#### GEORGIA DEPARTMENT OF TRANSPORTATION

Re: Cook County Airport Inspection

## **Cook County Airport Inspection Photos**

## Runway 5

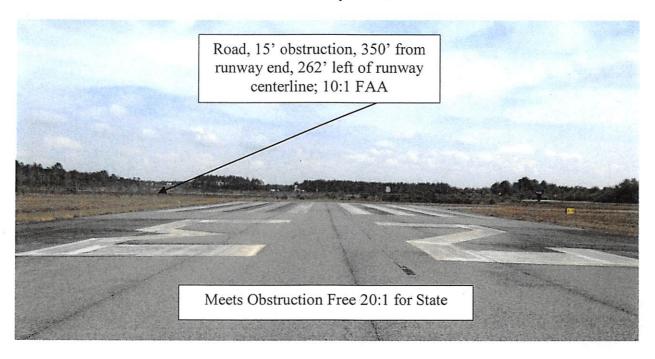
Runway 5 – Meets current minimum state licensing requirements for a 20:1 clear approach to the threshold, as well as meets the FAA Part 77 reporting requirements for a 34:1 obstruction-free, non-precision instrument approach to 200' from the runway end.

Runway 23 – Meets current minimum state licensing requirements for a 20:1 clear approach to the threshold, but fails to meet the FAA Part 77 reporting requirements for a 34:1 obstruction-free, non-precision instrument approach to 200' from the runway end. A road (an FAA presumed hazard of 15' tall) crosses the approach as close as 350' from the threshold, and provides only a 10:1 approach slope to 200' from runway end.

# Runway 15

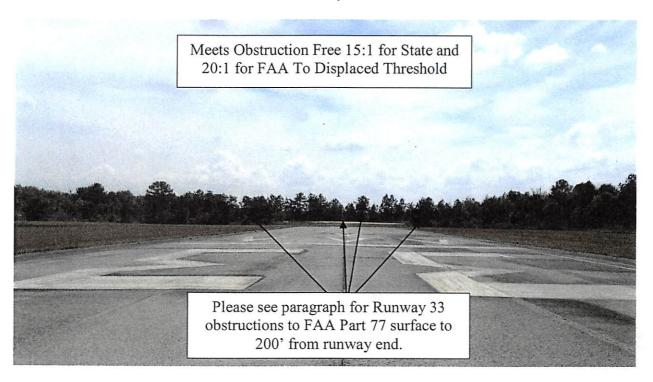
Runway 15 – Currently has a displaced threshold of 600'. Meets current minimum state licensing requirements for a 20:1 clear approach to the displaced threshold, as well as meets the FAA threshold siting requirements for a 20:1 obstruction-free, visual approach to the displaced threshold.

Runway 15 does not meet the FAA Part 77 reporting requirements for a 20:1 obstruction-free, visual approach to 200' from the runway end. A road (an FAA presumed hazard of 15' tall) crosses the approach as close as 395' from the threshold, and provides only a 13:1 approach slope to 200' from runway end. Since Runway 15 meets FAA and State standards to the displaced threshold, further mitigation is not required, but is recommended.

Runway 33 – Currently has a displaced threshold of 350'. Meets current minimum state licensing requirements for a 20:1 clear approach to the displaced threshold, as well as meets the FAA threshold siting requirements for a 20:1 obstruction-free, visual approach to the displaced threshold.

Runway 33 does not meet the FAA Part 77 reporting requirements for a 20:1 obstruction-free, visual approach to 200' from the runway end. A road (an FAA presumed hazard of 15' tall) crosses the approach as close as 260' from the threshold, and provides only a 4:1 approach slope to 200' from runway end. Trees, 20' tall, 201' from runway end, 75' left of centerline, block the approach (0:1) to 200' from runway end. Additional trees, 33' tall, 332' from runway end, across the approach, provide only a 4:1 approach slope to 200' from runway end. Additional trees, 20' tall, 201' from runway end, 77' right of runway centerline, block the approach (0:1) to 200' from runway end. Since Runway 33 meets FAA and State standards to the displaced threshold, further mitigation is not required, but is recommended.
